RE: HARLOW STAGE 6 - AMENDMENTS TO CONSTRUCTION PLAN APPROVAL

RE: HARLOW STAGE 6 - CONSTRUCTION PLAN APPROVAL

**HARLOW ESTATE
STAGE 6
ROAD AND DRAINAGE
FACE PLAN - SHEET 1
WYNDHAM CITY COUNCIL
SIG GROUP**

Drg No
309442CR400

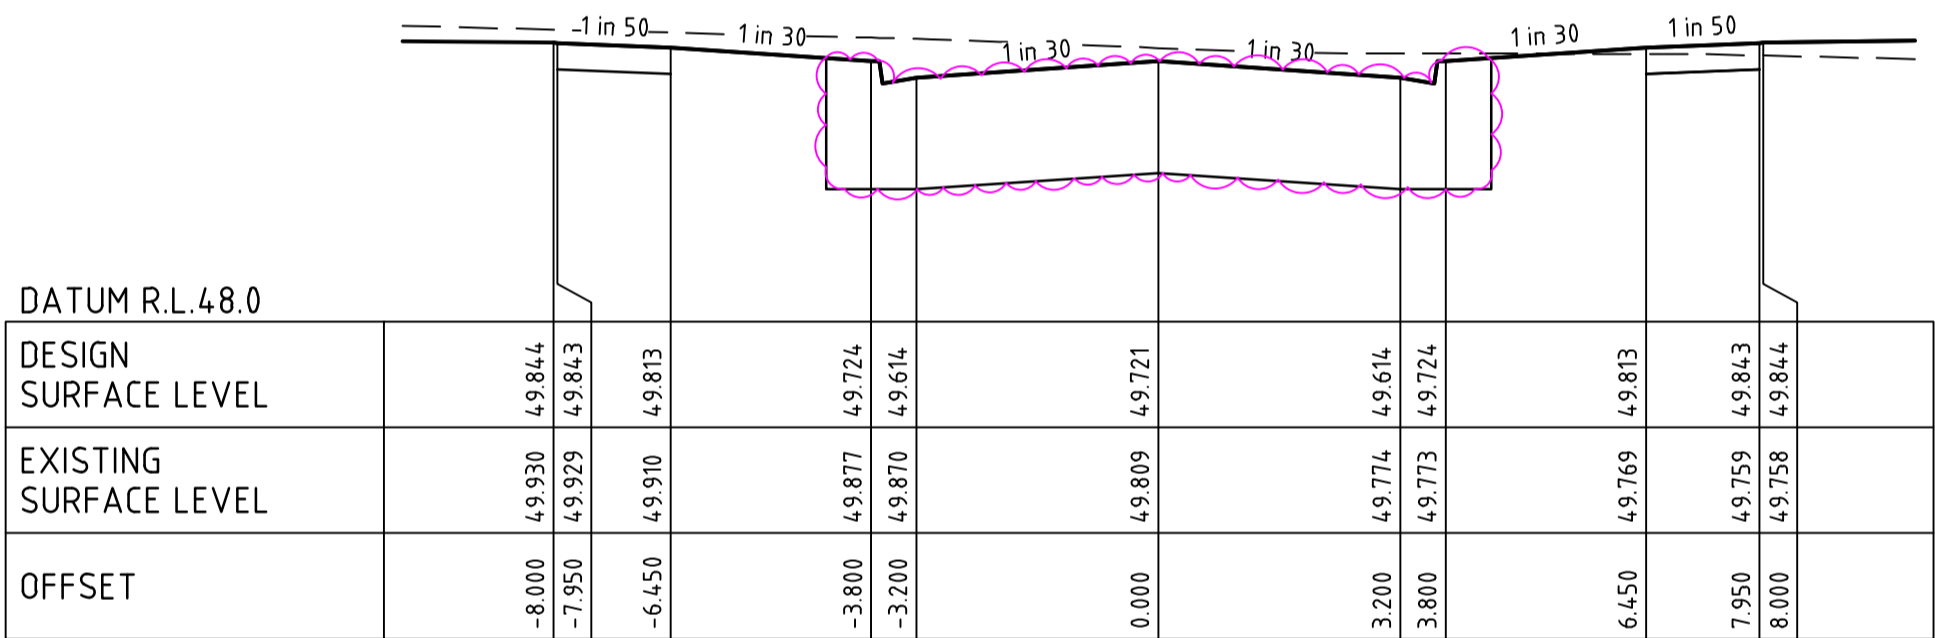
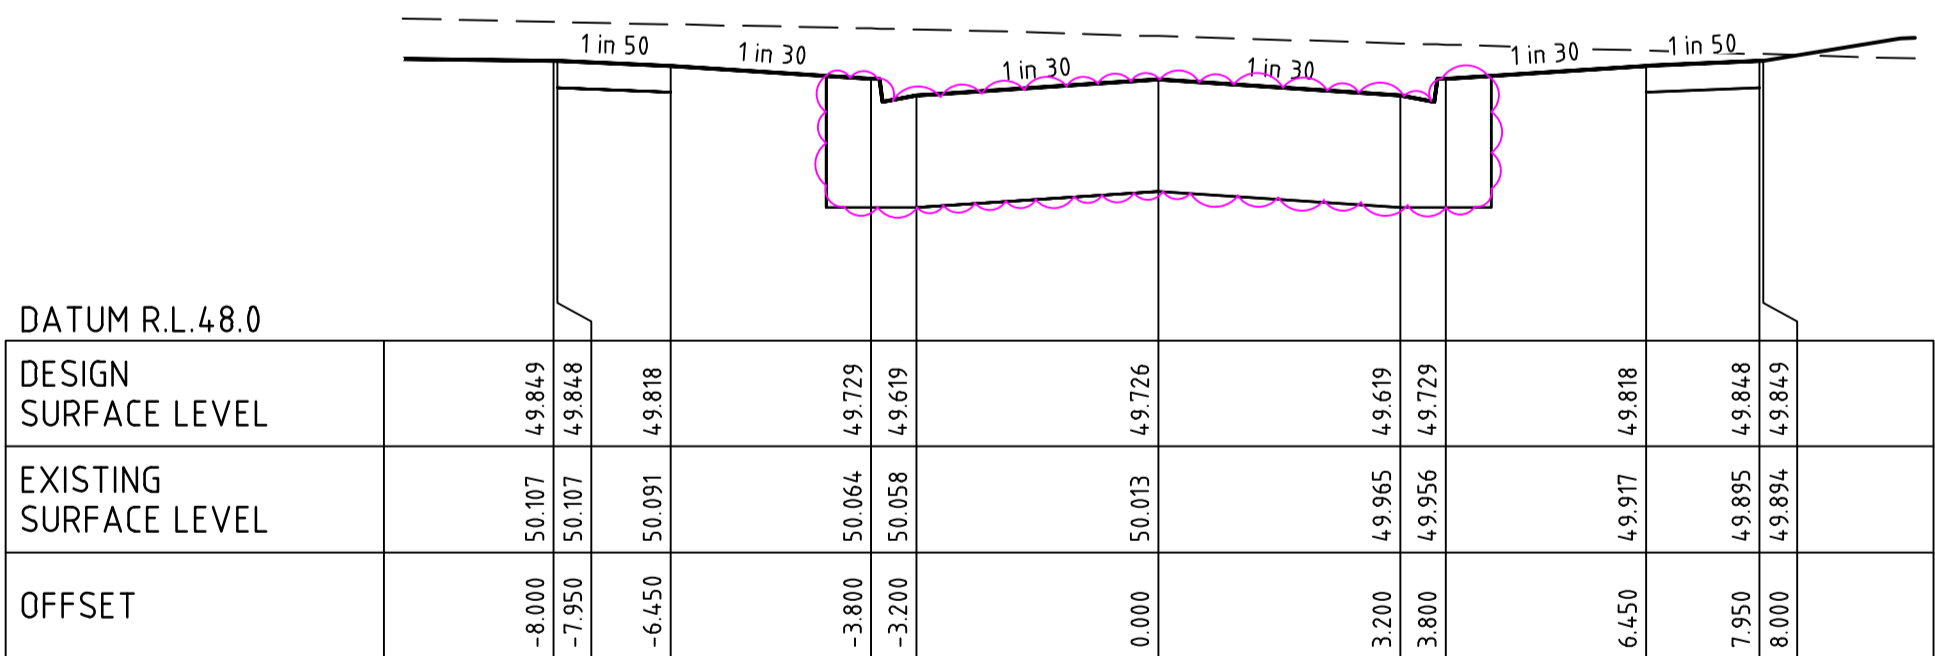
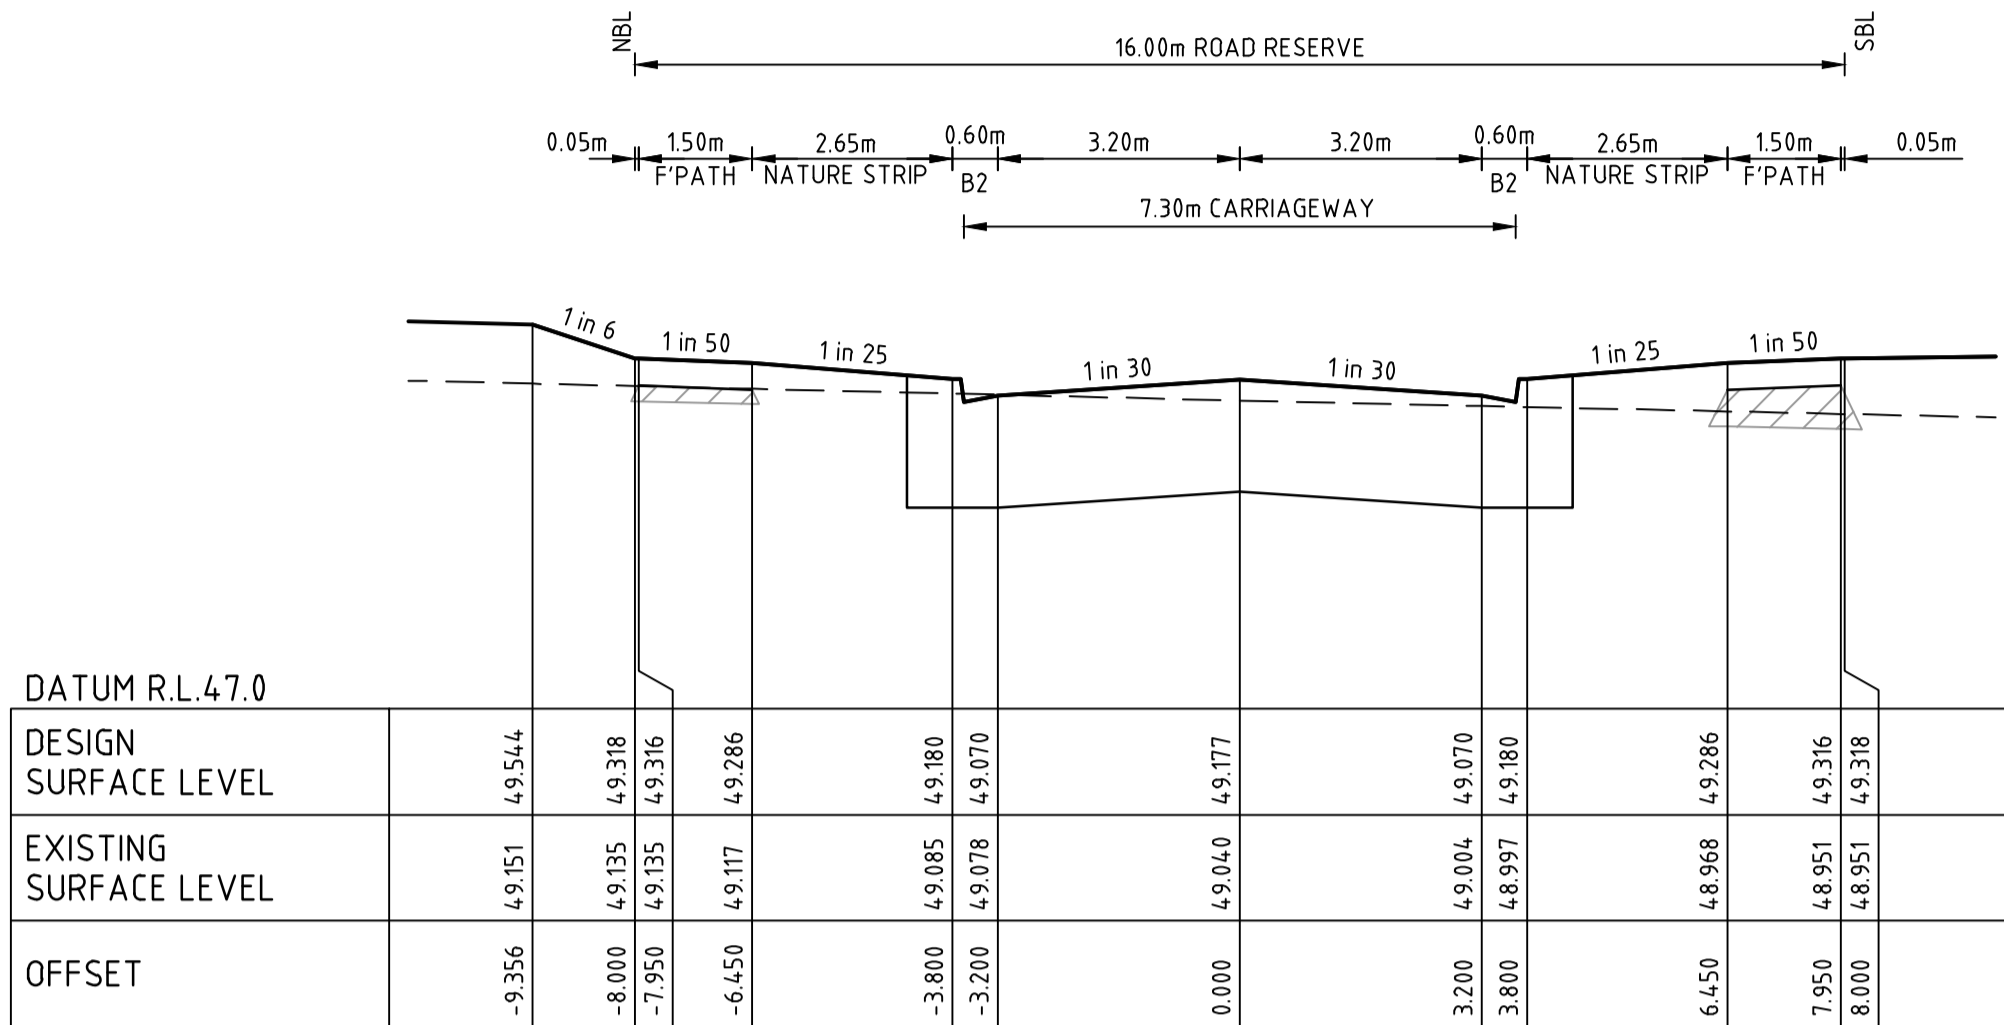
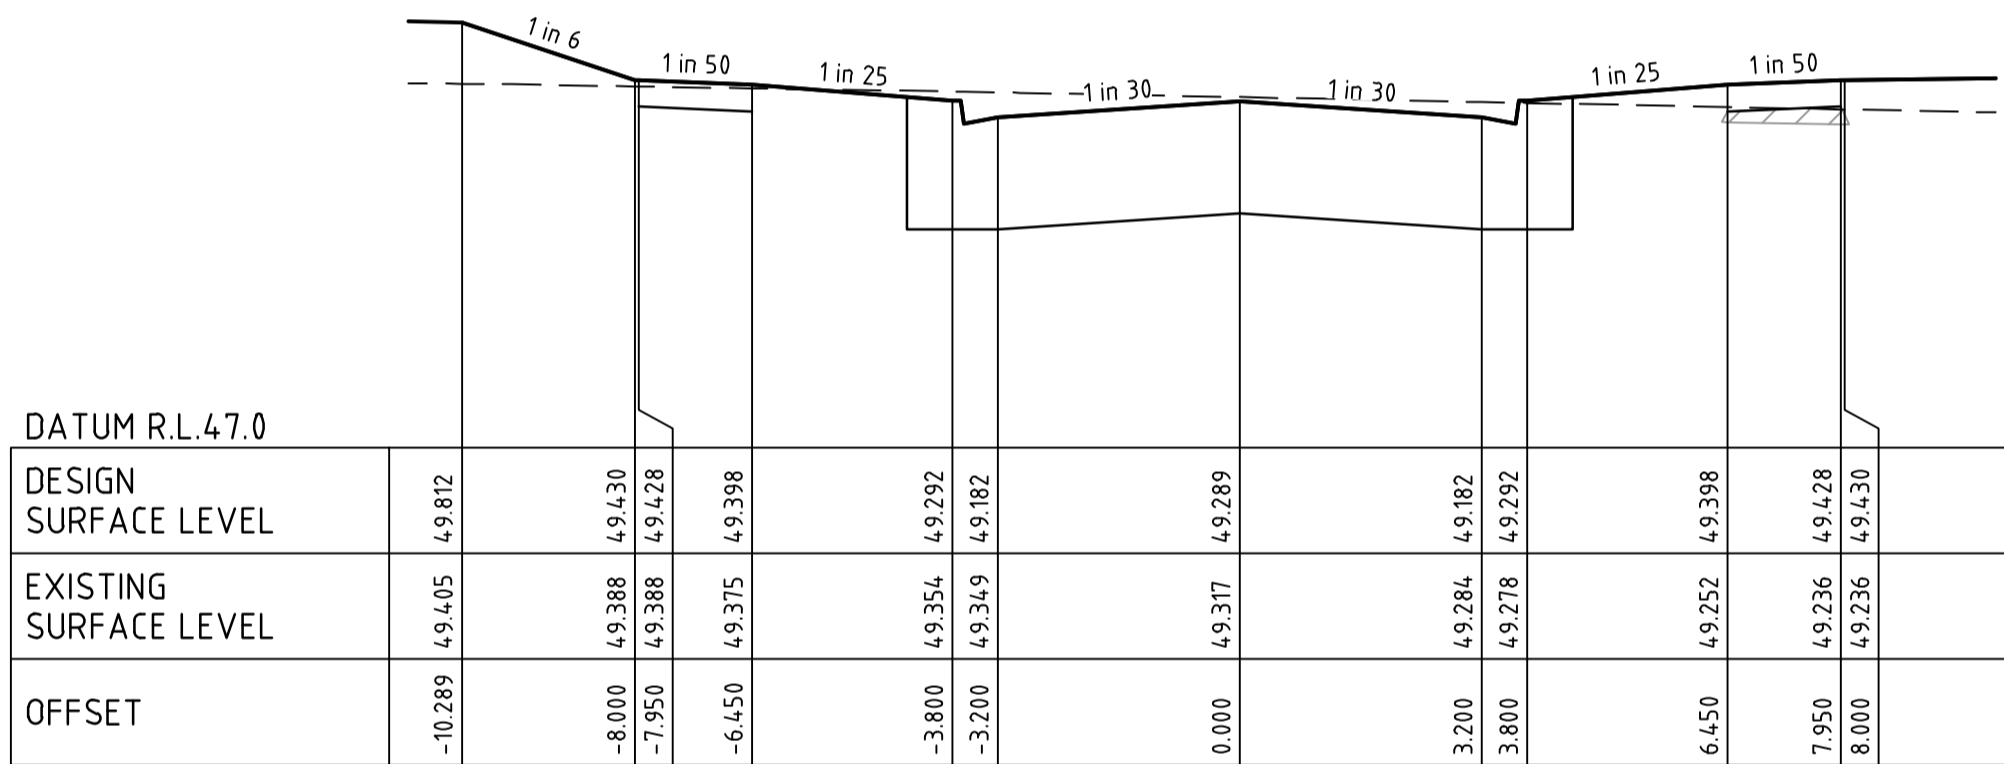
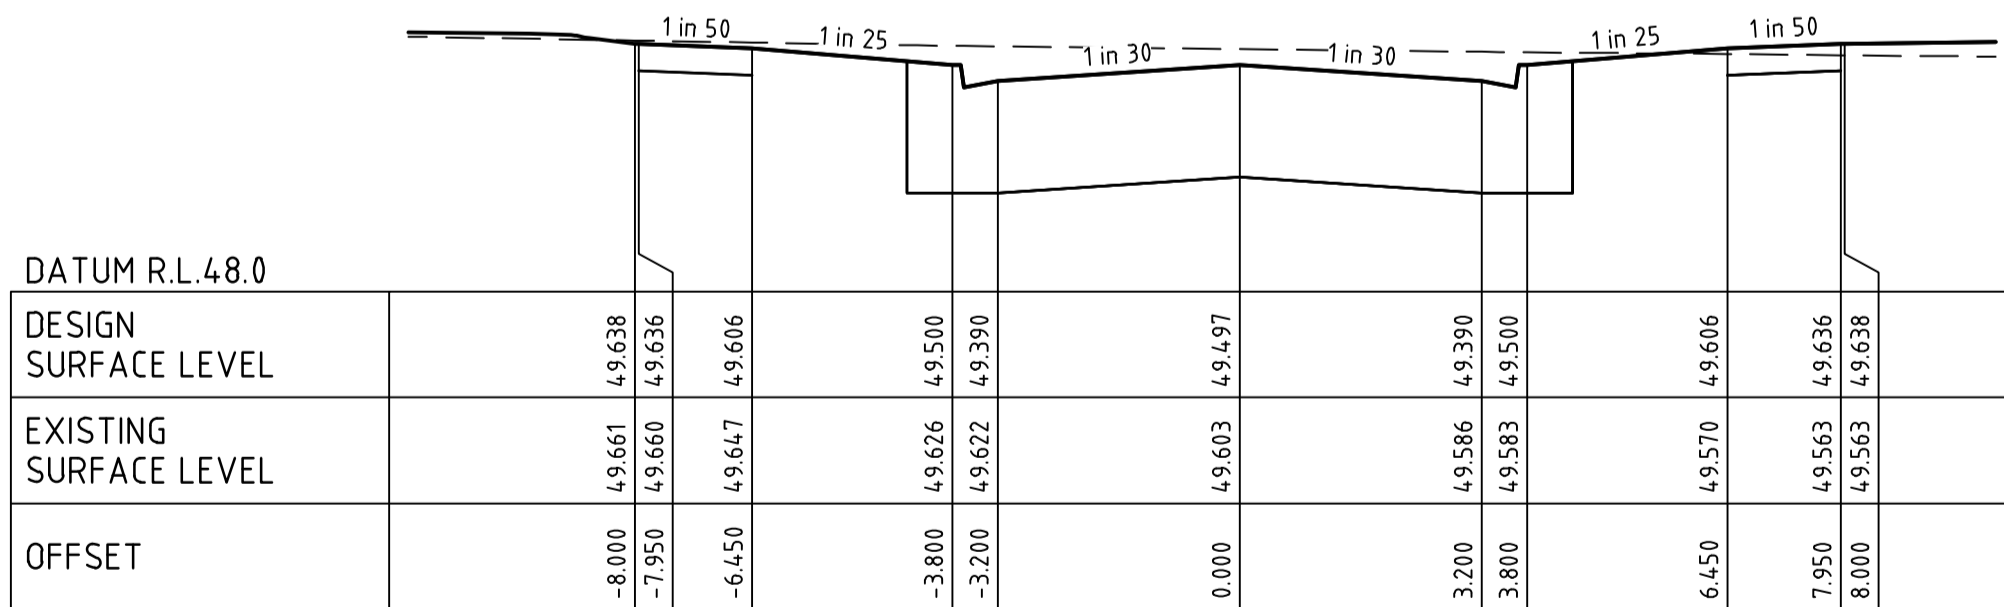
2	ROAD NAME & BOXING AMENDED	G.K	01/10/25
1	BOXING AMENDED	G.K	23/07/25
0	ISSUED FOR CONSTRUCTION	G.K	19/03/25
C	ROAD CROSS SECTIONS AMENDED	G.K	18/12/24
B	ISSUED FOR TENDER	G.K	16/12/24
A	ISSUED TO COUNCIL	G.K	01/11/24
Rev	Amendments	Approved	Date

CONSTRUCTION Drg No **309442CR500** Rev **1**

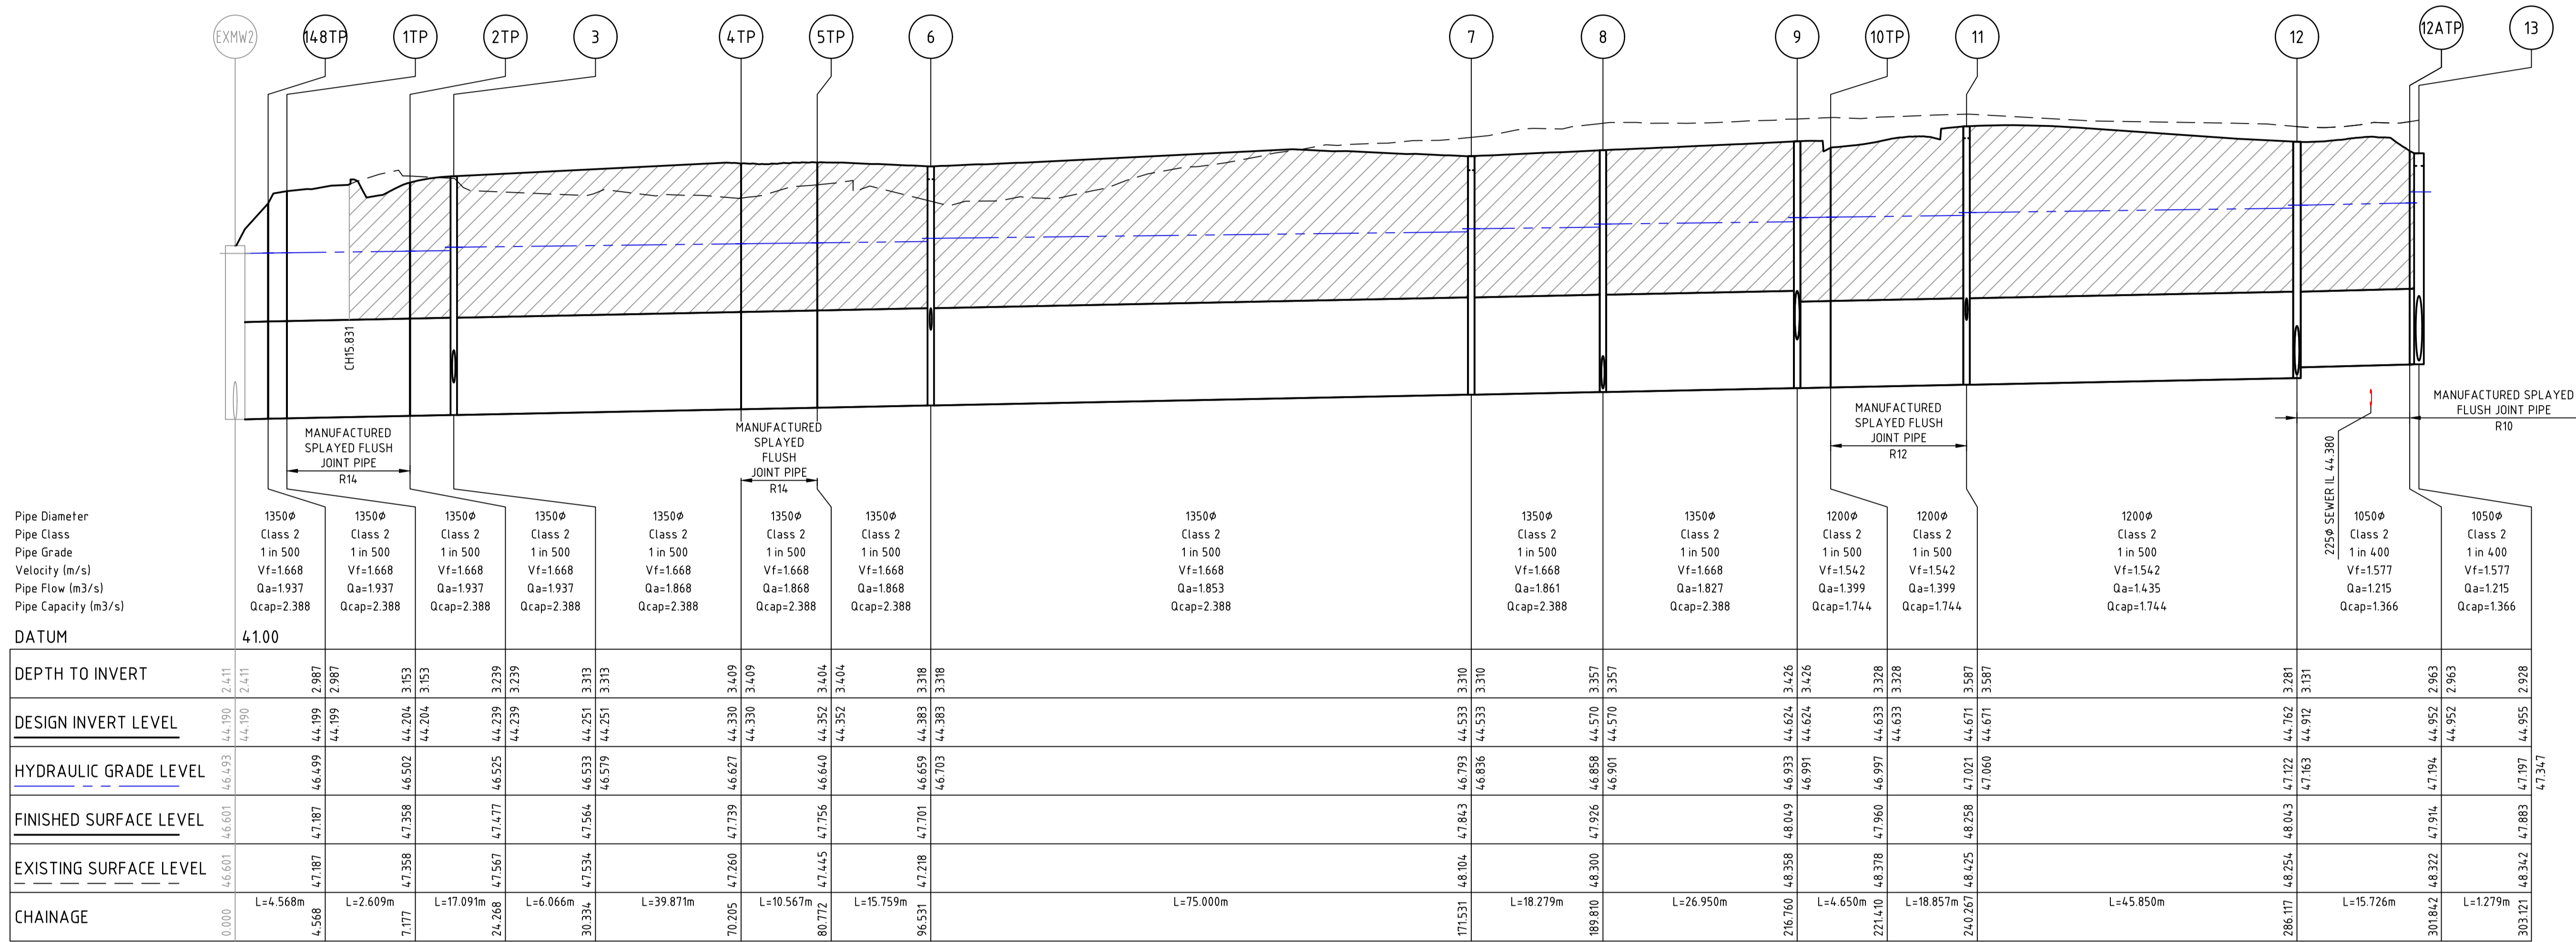
1	ROAD NAME AMENDED	G.K	01/10/25
0	ISSUED FOR CONSTRUCTION	G.K	19/03/25
B	ISSUED FOR TENDER	G.K	16/12/24
A	ISSUED TO COUNCIL	G.K	01/11/24
Rev	Amendments	Approved	Date
